SSD 7317 SECTION 4.55(1A) MODIFICATION (MOD 12) – AUSTRALIAN TECHNOLOGY PARK, EVELEIGH

This application has been prepared by Ethos Urban on behalf of Mirvac Projects Pty Ltd (Mircvac) pursuant to section 4.55(1A) of the *Environmental Planning and Assessment Act 1979* (EP&A Act) to modify State Significant Development 7317 (SSD 7317) which relates to the development of a commercial campus at the Australian Technology Park, Eveleigh.

Figure 2 The proposed modification to Indigenous Garden
 Source: Aspect Studios

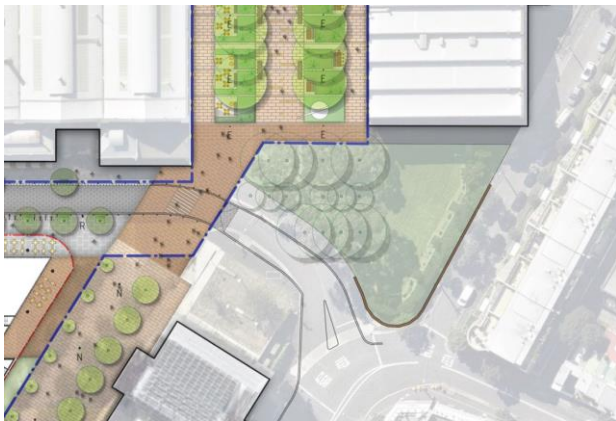
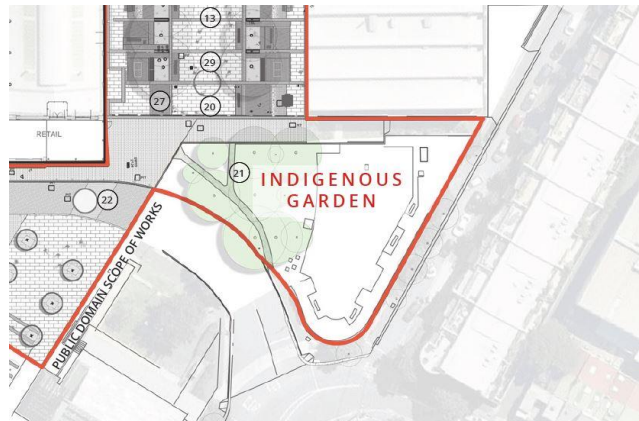
As illustrated in **Figures 3 and 4**, the Public Domain boundary is proposed to be extended to include a parcel of land along the eastern boundary of the ATP site. This parcel of land is included within the lot boundary for the SSDA 7317 development, however it was not originally included within the area to be upgraded as part of the Public Domain works.

It is intended that this additional parcel of land is to be converted into an Indigenous Garden, that will include an area of passive recreation that is respectful of the Indigenous heritage within the locality. The Indigenous Garden will feature pedestrian pathways, native indigenous plant species and areas for respite and relaxation. The detailed design of the Indigenous Garden will be confirmed within the Stage 2 Heritage Interpretation Plan for the Public Domain and the detailed construction level drawings will be provided to the PCA as part of the relevant construction certificate documentation.

Figure 4 The proposed wellness and skate/scooter park
 Source: Aspect Studios

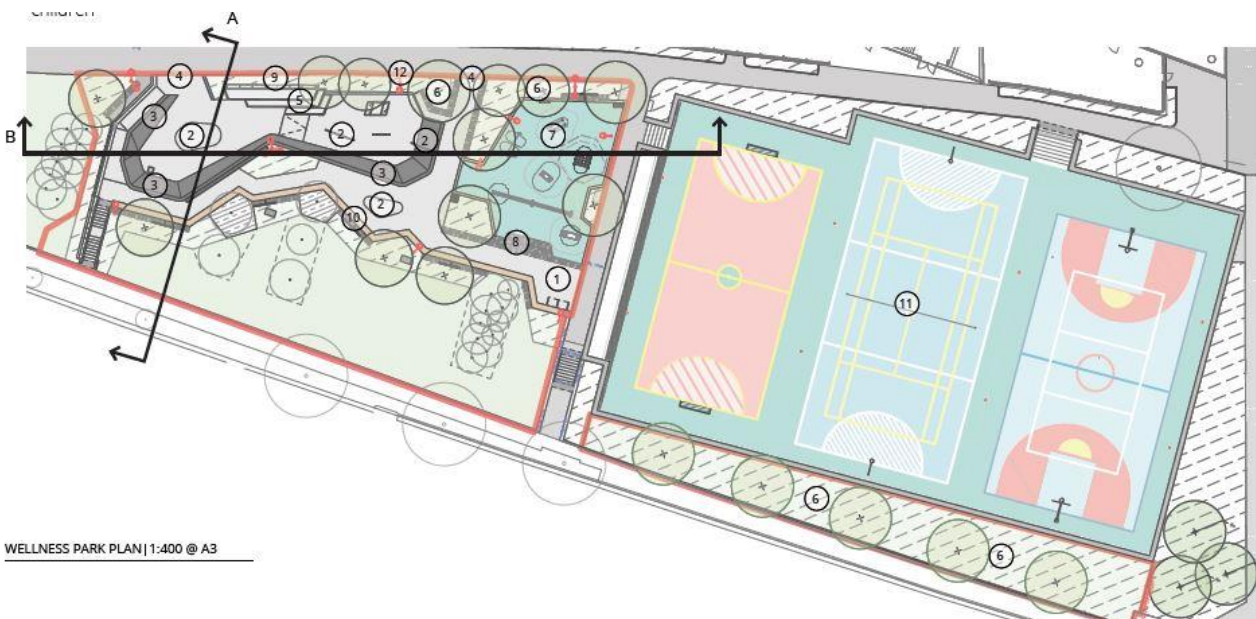
Mirvac seek approval to provide a Wellness Precinct that will comprise a wellness park and junior scooter park in place of an existing open turfed area along the south-east boundary of the ATP precinct, as shown in **Figure 4**.

The proposed Wellness Precinct layout, detailed sectional drawings, wall, bench and planting details are provided in the Public Domain Design Report included at **Attachment B**. The detailed construction level drawings will be prepared in accordance with the Landscape Masterplan and Public Domain Design Report (once approved) and provided to the satisfaction of the PCA within the relevant construction certificate documentation.
